Product Change Notice (PCN)

LFPCN2609001

New assembly plant for Littelfuse high voltage MOSFET in i4 package

Tube label

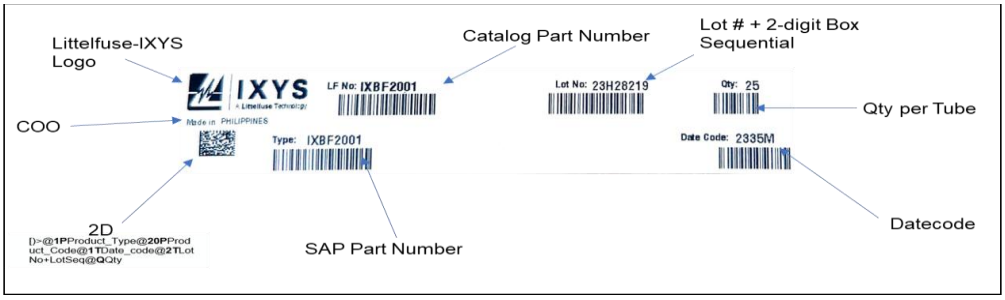
Description	Existing location	New location	Change
Unit Marking			
Logo	IXYS	IXYS A Littelfuse Technology	Y
UL Logo	No UL Logo	With UL Logo	Y
Isoplus Trademark	None	With trademark	Y
Partname	Device Name	Device Name	N
Date Code	FPMMDDYY	YYWW	Y
Assembly line code	P	M	Y
Lot #	Fab lot ID	Lipa Lot #	Y
Tube Label			
Logo	IXYS	IXYS A Littelfuse Technology	Y
Qty per tube	25	25	N
Part Number	Device Name	Device Name	N
Lot No	Fab Lot ID	Lipa Lot ID format	Y
Country of Origin	Yes	Yes	N
Code Type	Barcode	Barcode + 2D Code	Y
Date Code	None	YYWW	Y
Assembly line code	None	M	Y
Box Label			
RoHS Label			Y
Logo	IXYS	IXYS A Littelfuse Technology	Y
Qty per Box	250	250	N
Part Number	Device Name	Device Name	N
Lot No	Fab Lot ID	Lipa Lot ID format	Y
Country of Origin	Yes	Yes	N
Code Type	1DBarcode	1Barcode + 2D Code	Y
Date Code	None	YYWW	Y
Assembly line code	None	M	Y
